REMARKS/ARGUMENTS

Application Serial No. 10/673,014
Reply to Office Action of October 4, 2004

**Replacement Sheet of FIGS. 5A and 5B
(a total of ONE sheet of drawing)**

FIG.5A

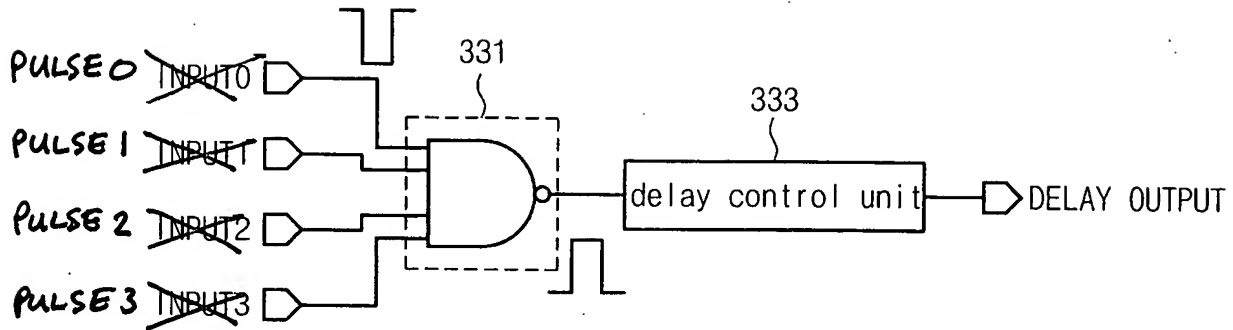
The Specification page 9, lines 2-8 and 12-19, and FIGS. 5A and 5B have been amended to remove inadvertent and minor typographical errors. No new matter has been added.

The attached sheets of drawings include changes to FIGS. 5A and 5B. These sheets contain corrections shown in red for the Examiner's approval and are requested to replace the original sheets of FIGS. 5A and 5B.
